Burntisland S.B.Co's No. 176

Adopted Alternative Arrangement of
Frame Bracket Connection

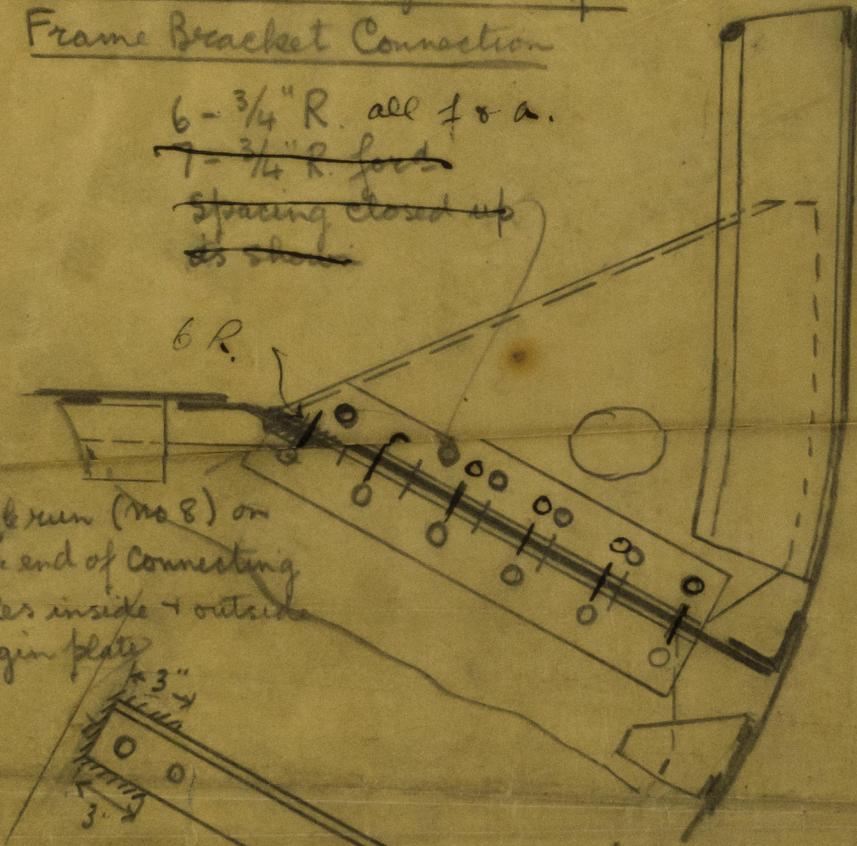
6 - 3/4" R. all for a.
~~7 - 3/4" R. for a.~~
~~Spacing closed up~~
~~as shown~~

x Single run (no 8) on
upper end of connecting
angles inside + outside
margin plate
